The Commission has issued the enclosed Amendment Nos. 56, 56 and 53 for License Nos. DPR-38, DPR-47 and DPR-55 for the Oconee Nuclear Station, Units 1, 2 and 3. These amendments consist of changes to the Stations common Technical Specifications and are in response to your request dated September 14, 1977.

These amendments revise the common Oconee Technical Specifications to incorporate changes to the Oconee Unit No. 3 pressurization heatup and cooldown limitations.

SAFETY EVALUATION BY THE OFFICE OF NUCLEAR REACTOR REGULATION

OCONEE NUCLEAR STATION, UNITS NOS. 1, 2 AND 3

Figure 3.1.2-1C

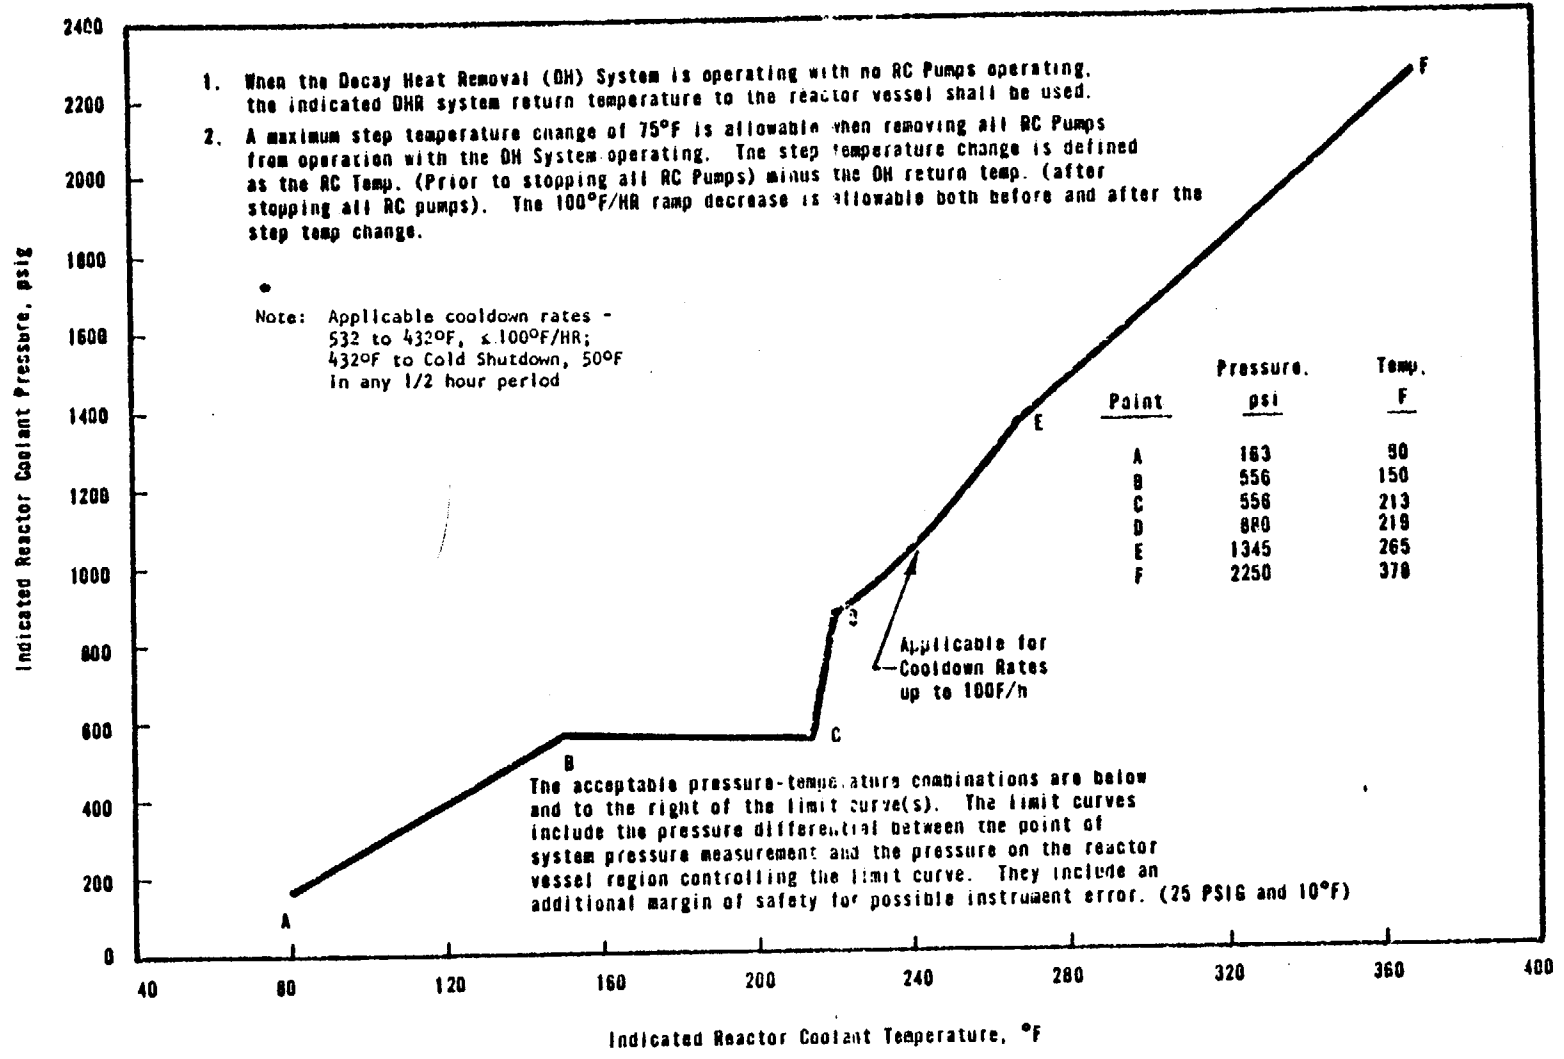
UNIT 3  
 REACTOR COOLANT SYSTEM  
 NORMAL OPERATION HEATUP LIMITATIONS  
 APPLICABLE FOR FIRST 4.0 EFY

The proposed revised Oconee Unit No. 3 pressure-temperature operating limit curves, Figures 3.1.2-1C, 3.1.2-2C and 3.1.2-3C are based on data from Babcock & Wilcox Report, "Analysis of Capsule OCIII-A From Duke Power Company Oconee Nuclear Station, Unit No. 3, Reactor Vessel Materials Surveillance Program," BAW-1438, dated July 1977. The proposed curves are projected for 8 EFPY.

We have reviewed BAW-1438 and the proposed pressure-temperature operating limit curves. Capsule A from Unit No. 3 contained specimens of weld metal WF 209-1. This weld is not identical to the welds in Oconee Unit No. 3. However, this weld has a similar chemical composition and was made using weld procedure similar to those for high copper Oconee vessel welds. Therefore, we conclude that the properties of the limiting weld metals in the Oconee reactor vessels will be affected by irradiation in a manner similar

Based on our review of the Oconee Unit No. 3 pressure-temperature limits and the similarity of the Oconee Unit No. 3, Unit No. 2, and Unit No. 1 designs, materials and operating conditions, we conclude that the operating limits proposed for Unit No. 3 are in conformance with Appendix G, 10 CFR Part 50, and are therefore acceptable.

Figure 3.1.2-2C

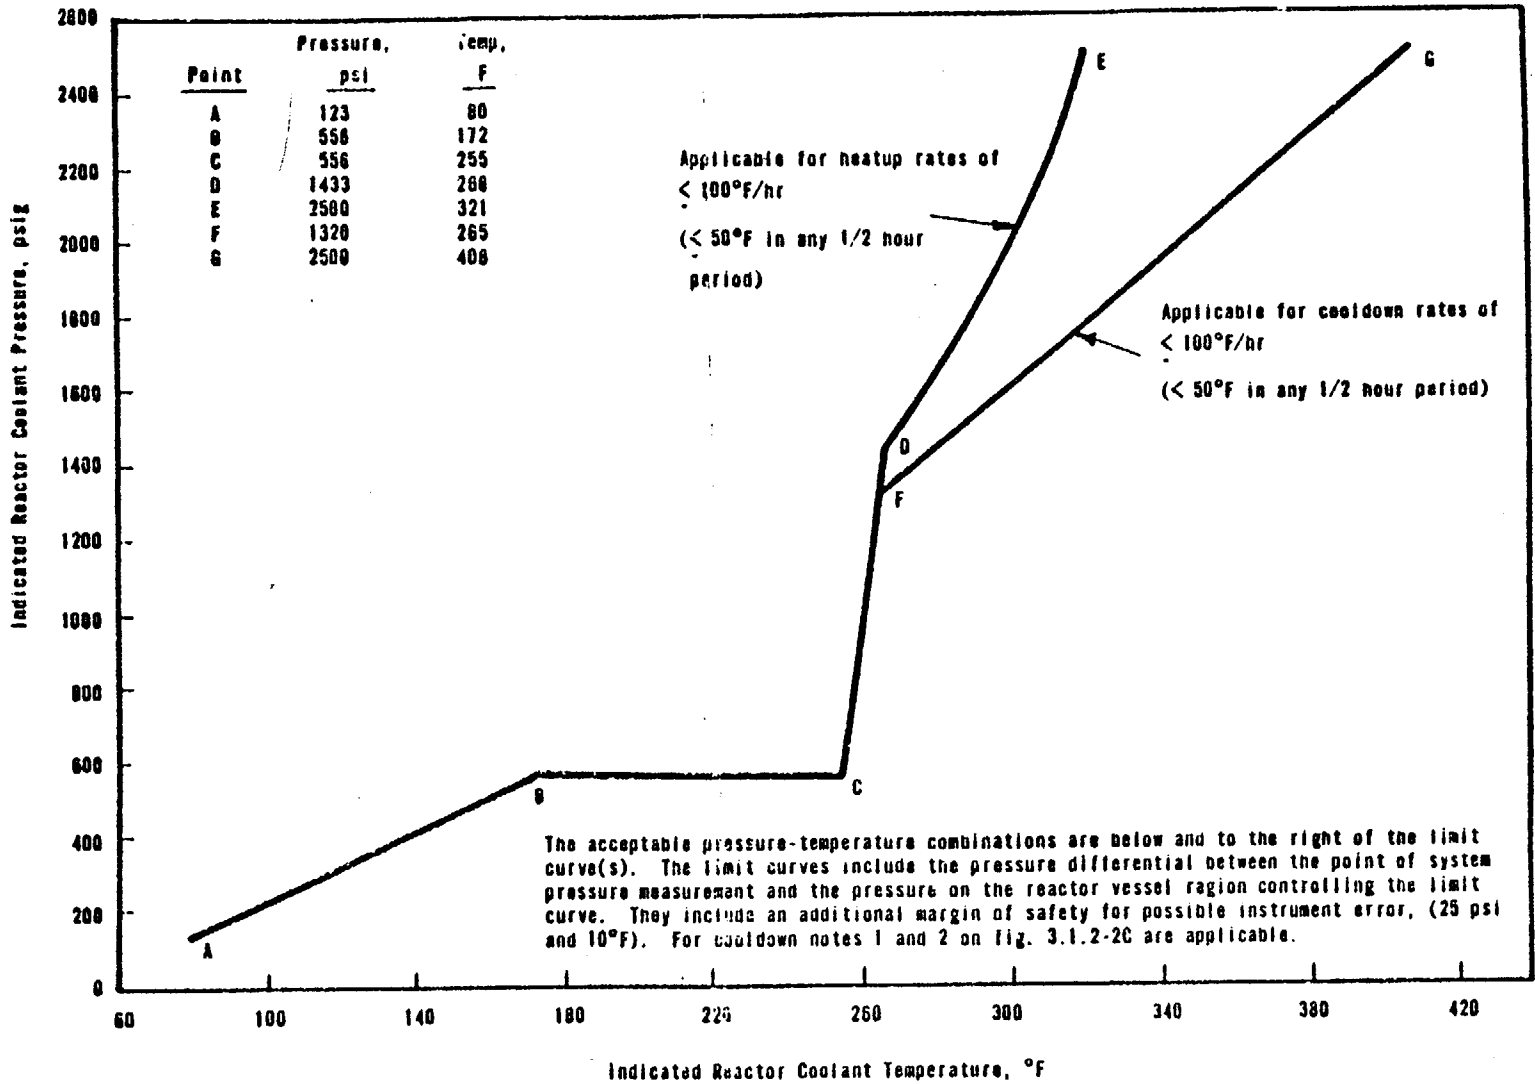
UNIT 3  
 REACTOR COOLANT SYSTEM  
 NORMAL OPERATION COOLDOWN LIMITATIONS  
 APPLICABLE FOR FIRST 4.0 EFY
